## **1973 Corvette: Service Bulletin: Exhaust Manifold Heat Shielding**

**Chevrolet  
Dealer  
Service  
Technical  
Bulletin**

73-T-8

Subject: EXHAUST MANIFOLD HEAT SHIELD -  
1973 CORVETTE WITH 350 CU. IN.  
ENGINE WITH AIR CONDITIONING

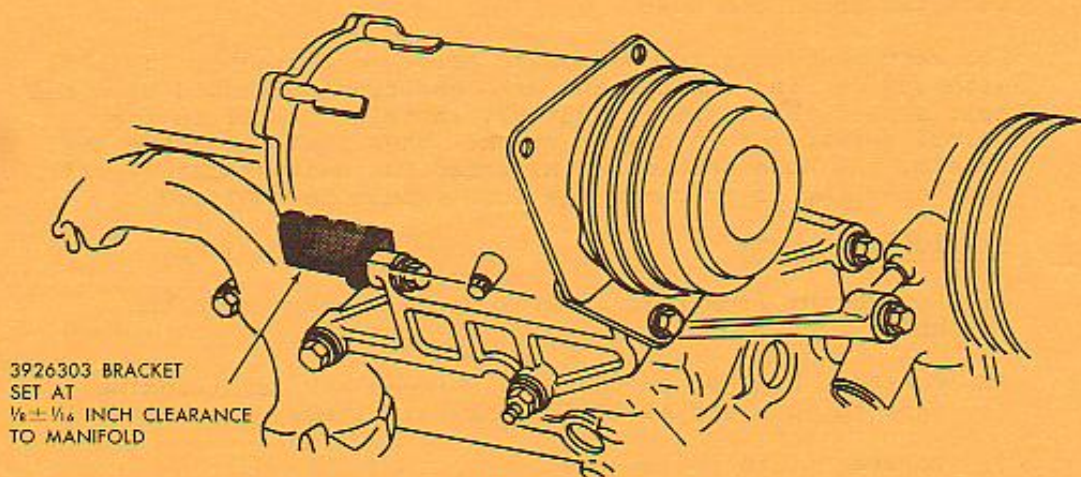
Some early production 1973 Corvettes equipped with 350 cu. in. engines and air conditioning may experience air conditioning hose damage due to close proximity of the exhaust manifold.

Corvettes assembled after September 13, 1972, have a heat shield installed between the hose and the manifold to protect the hose from heat.

For service, Corvettes assembled prior to September 13, 1972, with 350 cu. in. engines and air conditioning should have the heat shield, Part Number 3926303, installed while in for normal service or in dealer stock. When installing the heat shield, the hose should be inspected for heat cracking. If heat cracking is evident, the hose should be replaced.

- 1) Remove nut from rear compressor to bracket mounting bolt.
- 2) Position bracket on bolt and between air conditioning suction hose and manifold as illustrated.
- 3) Torque nut to 25 ft. lbs.
